2-4 Hale Street, Botany | Building Waste Transfer Facility

Noise and Vibration Impact Assessment

Revision 009

1.2 NSW EPA COMMENTS – MAY 2025

Figure 1: Acoustic site plan identifying the surrounding noise-sensitive receivers and relevant noise monitoring locations (source: SixMaps NSW)

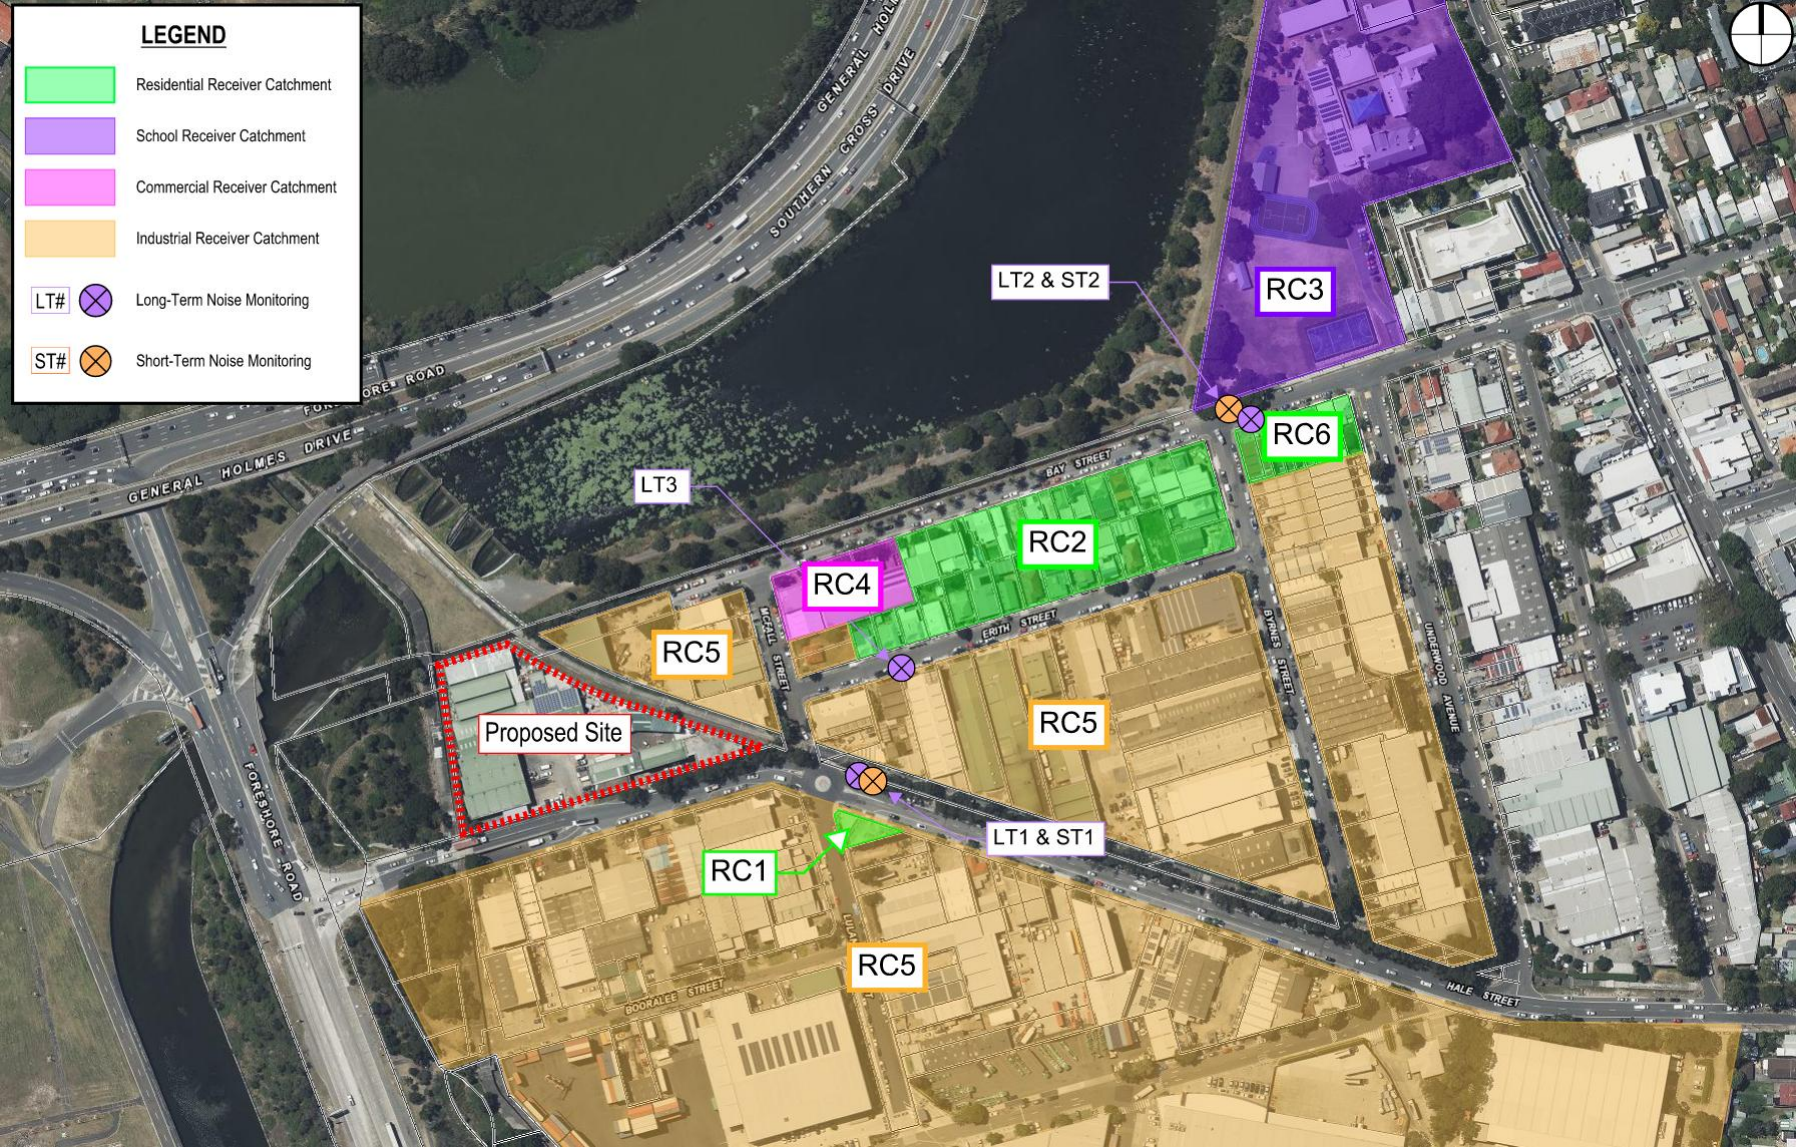
NSW EPA COMMENT	ELAB RESPONSE	REPORT REFERENCE
<p>Identification of sensitive receivers</p> <ul style="list-style-type: none"> The assessment has categorized nearby residential areas into two groups: RC1 and RC2. As shown in Figure 1 and Table 2 of the NVIA, RC1 is a residential area located within the industrial zone, approximately 80 meters from the proposed development. While the specific addresses of the residential dwellings within RC1 have not been provided, ambient noise monitoring has been conducted at a location identified as LT1 - 3 Hale Street Botany, at the corner of Luland Street. Based on the information presented in Figure 1, it appears that LT1 and RC1 are likely located at 3 Luland Street Botany, rather than 3 Hale Street Botany. Further clarification regarding the exact locations of RC1 and LT1 is necessary. The assessment currently does not include or consider the potential noise impacts on residential properties located on Erith Street, approximately 100 meters from the proposed development. It is essential to evaluate the noise exposure of residences on the northern side of Erith Street within the NVIA. A comprehensive land use survey should be conducted to accurately determine the location of sensitive receptors, such as residential properties, schools, and hospitals, in relation to the proposed development. This information will be crucial for assessing potential noise impacts and implementing appropriate mitigation measures. 	<p>Table 4 and Figure 3 have been updated to clarify the location of residential receivers RC1 (3 Luland Street, Botany). The residences along Bay Street and Erith Street have also been separated into two receiver catchments (RC2 and RC6).</p> <p>The Erith Street residences approximately 100m from the proposed development were previously assessed as RC2 (specifically 26 Erith Street, the western-most residence closest to the proposed development). An updated site map and receiver catchment description is provided in Table 4 and Figure 3 to reflect this.</p> <p>The NSW Government Sharing and Enabling Environmental Data (SEED) land zoning maps are referenced in Figure 2 to determine the land zoning of nearby development, and to determine the most affected receivers surrounding the proposed development.</p> <p>The corresponding assessments in Section 7 and 8 have been updated to incorporate specific land zoning where applicable.</p>	<p>Section 3.1</p> <p>Section 3.1</p> <p>Section 3.1</p>

Figure 6: Noise monitor location LT1 (Image 1)

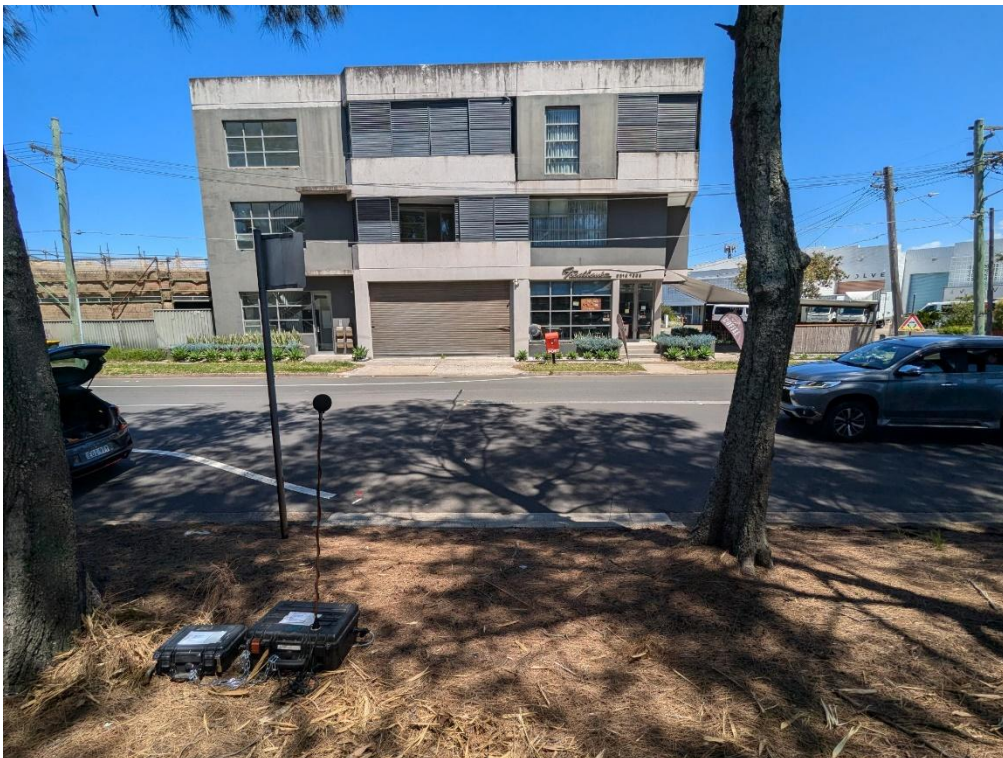
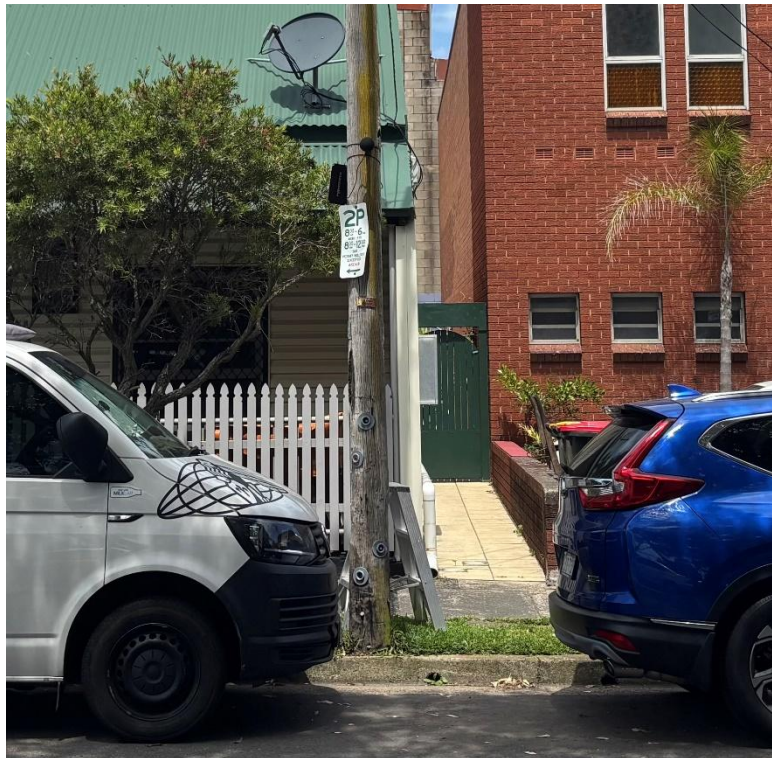
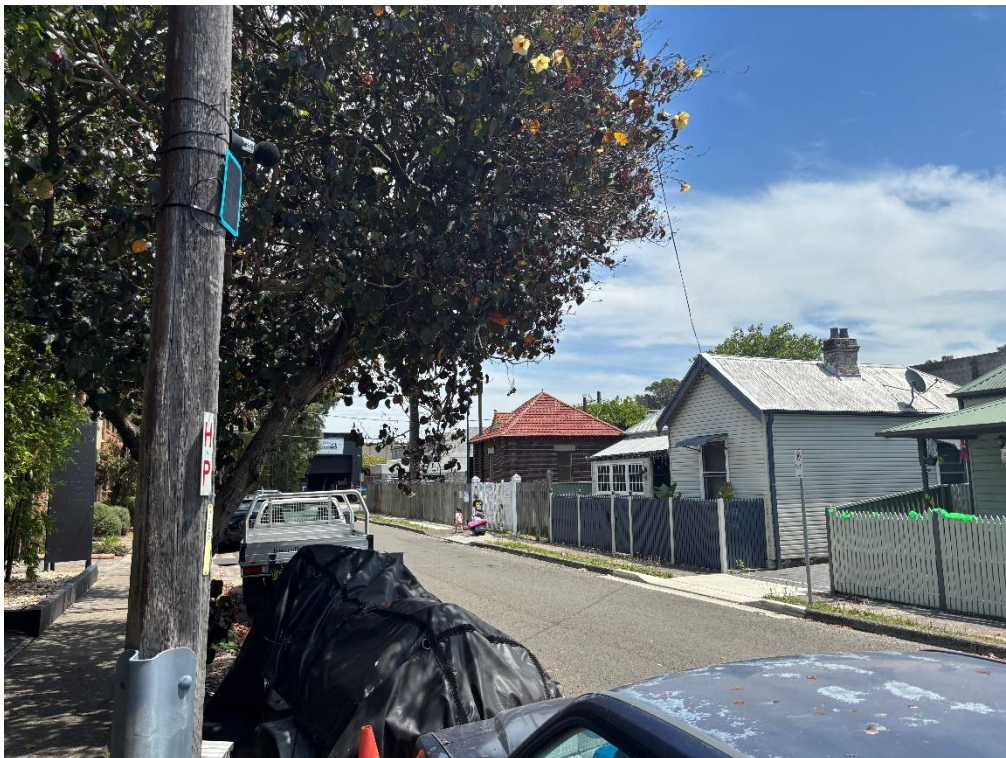
NSW EPA COMMENT	ELAB RESPONSE	REPORT REFERENCE
<p>requirements for the location of monitoring equipment used to assess background noise levels.</p> <p>It is essential to provide comprehensive information about the micro location of the monitoring instruments, along with an evaluation demonstrating compliance with the NPfl's locational guidelines.</p> <ul style="list-style-type: none"> Monitoring Location Requirements: The NVIA indicates that the same monitoring locations, LT1, LT2, and LT3, were used to assess both background noise levels and existing traffic noise levels. However, the locational requirements for measuring background noise and traffic noise differ. The NPfl mandates a free-field location, while the Road Noise Policy (RNP) requires a reverberant location within 1 meter of the exposed façade. As highlighted earlier, it is crucial to provide a detailed description of the monitoring instruments' micro locations and justify their compliance with the specific requirements of both the NPfl and RNP. Depending on the actual placement, adjustments to the measured noise levels may be necessary. Furthermore, it is unlikely that the noise levels measured at LT1 or LT2 accurately represent the noise exposure experienced by residents on Erith Street Botany. 	<ul style="list-style-type: none"> Approximate locations in the site map in Figure 3. Detailed descriptions provided in Table 7. Photographs of noise monitor locations in Appendix A. <p>Background noise levels in this assessment have been obtained from additional monitoring conducted in October-November 2024. Detailed descriptions and photographs have been provided in the sections noted above. The following is noted:</p> <ul style="list-style-type: none"> For the purpose of our assessment, noise monitoring has been used to determine background noise levels (L_{90}) and equivalent continuous noise levels (L_{eq}). In the assessment of traffic noise generation from the proposed development, we have noted: <ul style="list-style-type: none"> Heavy vehicles entering and departing the site will not create any significant noise impacts to surrounding residences due to the direction of travel. All heavy vehicles will enter and depart the site from the west. Light vehicles entering and departing the site have been conservatively assumed as 4 movements in a peak hour. The increase in noise from additional traffic generated by the development will satisfy the RNP requirements identified in Section 6.2 (in isolation of existing traffic noise levels). The proposed development will result in a net traffic generation reduction during both AM and PM peak periods. 	<p>Section 3.1 and 8.4</p>

NSW EPA COMMENT	ELAB RESPONSE	REPORT REFERENCE
<p>Noise Monitoring Equipment</p> <ul style="list-style-type: none"> Instrumentation used to quantify existing noise levels in the area does not meet the performance and location specifications (i.e. AS IEC 61672 and height above ground) required by the Noise Policy for Industry (NPfI – EPA, 2017). Additional information is required before a definitive determination can be made regarding accepting the results of the ambient noise monitoring presented in the assessment. 	<p>While AS/NZS 1055 and the NSW NPfI reference 1.5 m as a standard microphone height, the guidelines permit alternative heights where site conditions warrant. For this project, unattended monitoring was installed at 2.5 m to prevent vandalism and unauthorised tampering, especially due to intoxicated patrons leaving the nearby brewery on Erith Street observed during the late night. Attended measurements at 1.5m were also undertaken for verification are generally in-line with the results obtained during long-term noise monitoring (as per Table 6) — within instrument uncertainty. Accordingly, the elevated microphone height does not affect the representativeness of the results.</p>	<p>Appendix A</p>
